Isolation Proposals, Revised 2025-03-~~12~~13

Submitted by Jason Potterf - Cisco

Topic: Clause 189 Isolation Section Rewrite

Revise Section 189.6.2 Electrical isolation as follows:

Figure J-1 Isolated MPoE System Diagram

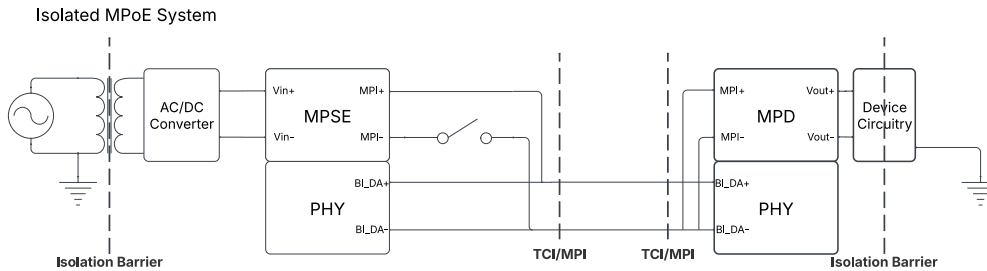
Isolated MPoE systems, as shown in Figure J-1, are recommended for mixing segments that cross any of the following:

- Ground references
- Boundaries between separate power distribution systems
- Boundaries of a single building

Isolated MPoE systems have isolation requirements that are aligned with Clause 33 and Clause 145 isolation requirements. These isolation requirements target compatibility with low-voltage systems that prohibit intentional grounding of any conductor, such as a Safety Extra-Low Voltage (SELV) system. Because the MPSE outputs are isolated and floating, disconnecting the more negative conductor is sufficient to stop the flow of power and ground loops are not present.

Figure J-2 Grounded MPoE System Diagram

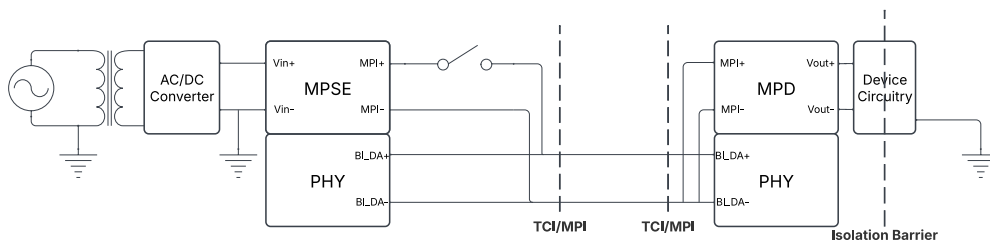
Grounded MPoE systems, as shown in Figure J-2, are recommended for mixing segments which, with all associated interconnected equipment, share a common, continuous ground.

Grounded MPoE systems have isolation requirements that are aligned with Clause 104 isolation requirements. These isolation requirements target compatibility with low-voltage systems that intentionally ground one conductor, such as a Protective Extra-Low Voltage (PELV) systems. Grounded MPSEs are permitted to ground the more negative conductor of their power supply, but are specified below to switch their more positive conductor to ensure that a ground path does not circumvent the MPSE's ability to stop the flow of power. MPDs are specified to meet a lower isolation requirement to ensure the current supplied by the MPSE on the MPI returns to the MPSE via the MPI.
